ATTENTION: MIKE FINE

FROM: PETER DRISCOLL

SENIOR FLEXONICS  
METAL BELLOWS DIV.

TITLE			
END FITTING			
SIZE	CAGE CODE	DWG. NO.	REV
A	07649	mod47288-100A	
SCALE	1/1	SHEET 1 OF 1

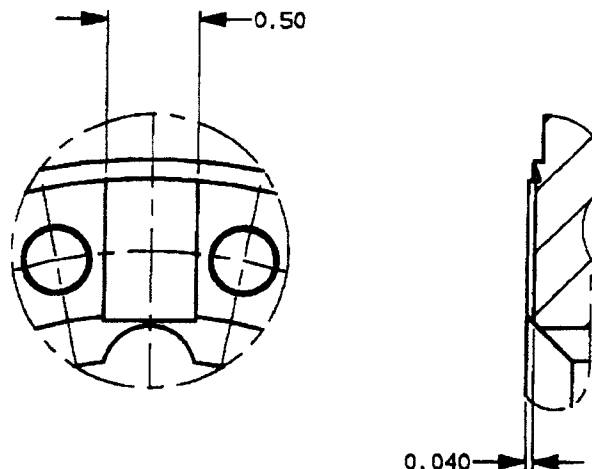
VENT SLOT = .37" X .063"  
*PD*

OPTION 1

(USING  $\phi$ .125 END MILL)

VENT SLOT = .50" X .040"  
*PD*

OPTION 2

(USING  $\phi$ .125 END MILL)
